Preliminary Consultation 10600 River Road #29/7 MacDonald Hs

HISTORIC PRESERVATION COMMISSION STAFF REPORT

Address: 10600 River Road Meeting Date: 01/25/95

PROPOSAL: Demolish addition; reconstruct RECOMMEND: Further study

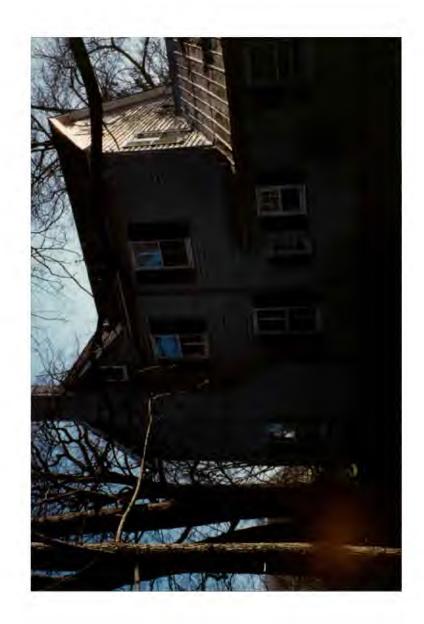
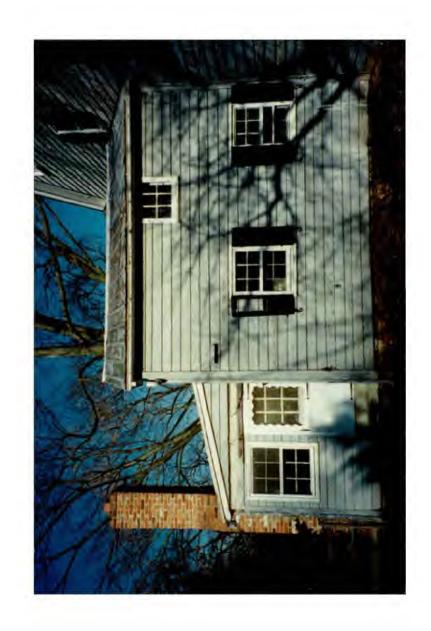
Staff feels that an addition to the rear of the MacDonald House is possible. However, staff is concerned that substantial demolition is proposed and more information is needed as to how much historic fabric would be involved.

Staff suggests that the applicant provide additional information as to whether the existing rear additions are 20th century or 19th century. The concrete block foundation may indicate 20th century construction but more information is needed. If the rear additions are 20th century, demolition and replacement may be appropriate. If they are 19th century, minimal demolition should occur. However, the project could involve the raising of the roof of the first addition below the eave of the main house, with possible demolition of the shed addition and fireplace.

In any case, the fireplace should be re-built with the same features to match other external fireplaces on the main block. A tin roof with gabled dormer would be appropriate for the proposed addition. Staff does not find an increase in mass or footprint problematic in the squaring off of the block, but strongly suggests that as much as possible of the historic fabric should be maintained.

Staff applauds the applicant for their decision to reverse earlier incompatible change to window openings. However, proposed openings should be 6/6 without transom and shuttered. The size of the openings may vary, but the configuration should be consistent.

Finally, should the applicant re-submit a revised proposal, the proposal should be adequately dimensioned with material description on both floor plans and elevations so that staff can adequately review.
